**ADDENDUM TO THE
LOCATION HYDRAULIC STUDY REPORT**

**FOR THE
INTERSTATE 80/GILMAN STREET INTERCHANGE
IMPROVEMENT PROJECT**

ALAMEDA COUNTY, CALIFORNIA
District 04 -ALA – 80 – POST MILE 6.38 / 6.95
EA 04-0A7700 / Project ID# 0400020155

NOVEMBER 2018

Figure 6. Project layout showing the low points susceptible to sea level rise

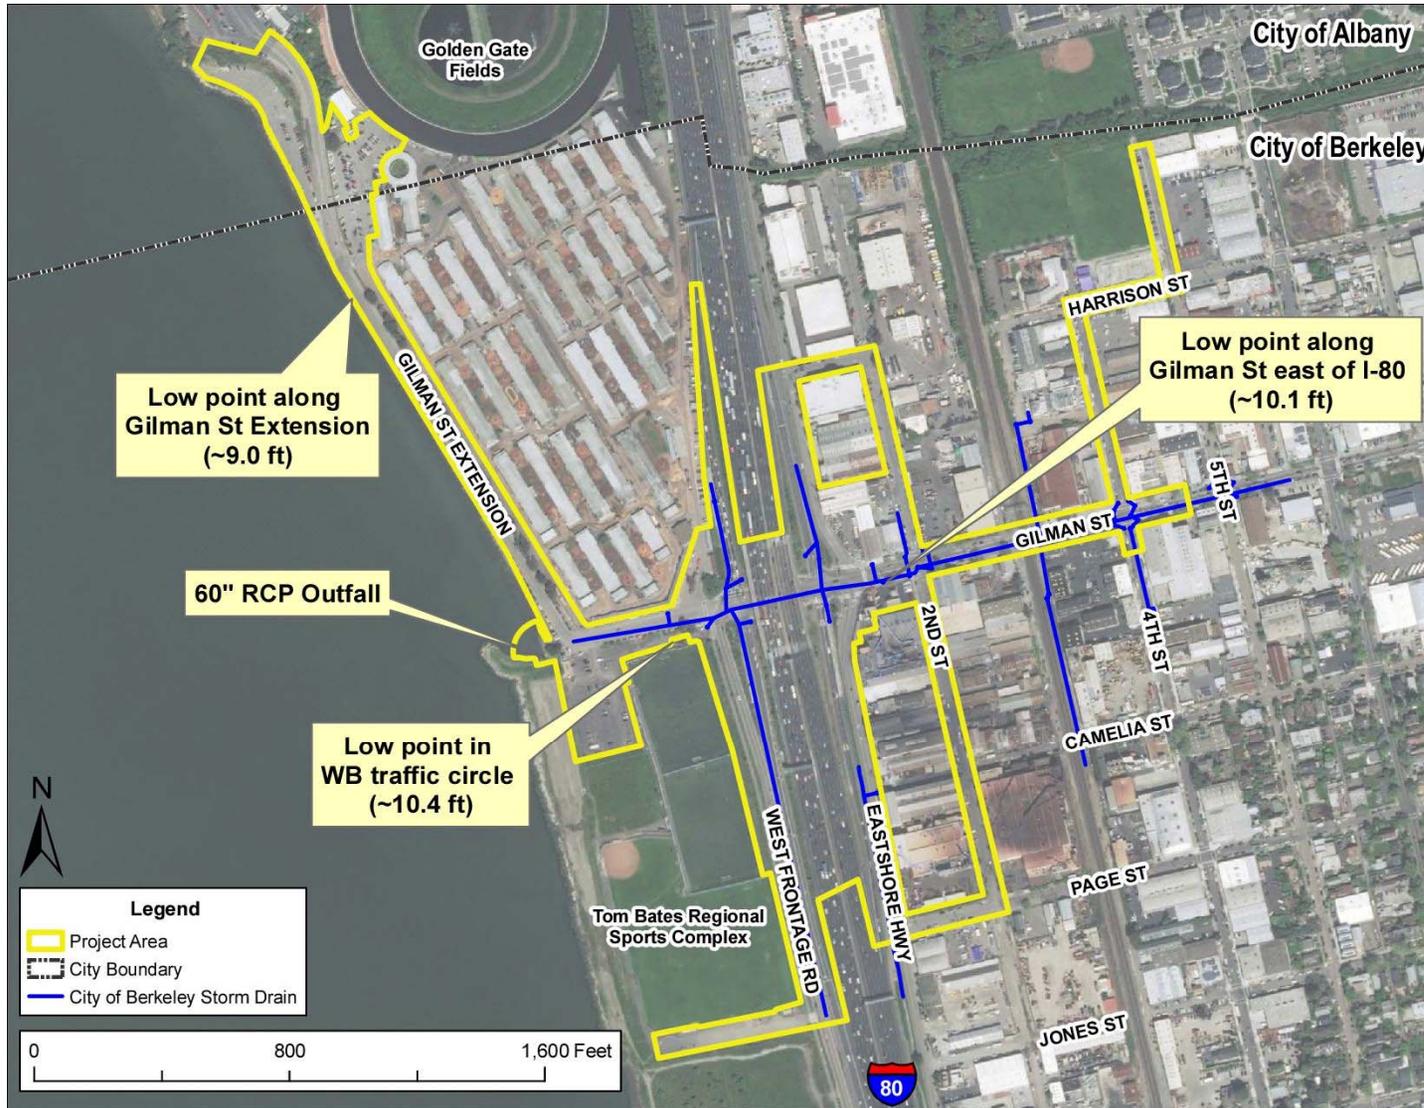
With this projection, the tidal 100-year stillwater elevation at the Project location would increase to approximately 11.2 feet NAVD 88. There are local low points at a drain inlet on the southwestern edge of the westbound traffic circle with an approximate elevation of 10.4 feet NAVD 88 and along Gilman Street Extension with an approximate elevation of 9.0 feet NAVD 88. The area around these low points would be especially susceptible to impacts from SLR during the 100-year flood event due to backflow through the drainage system or from overland tidal inundation. A tidal flap gate is proposed at the Gilman Street outfall to prevent tidal backflow from entering into the Project area. More information about the tidal flap gate is discussed in Section 4.2. In addition, the road surface elevations and the storm drain inlet elevations around the 2nd Street and Gilman Street intersection, the Gilman Street Extension, and the Golden Gate northwest and northeast parking lots range from 9.0 to 15.0 feet NAVD 88. These areas are susceptible to backflow through the storm drain system or overland tidal inundation when accounting for SLR.

The following figure in this section was revised:
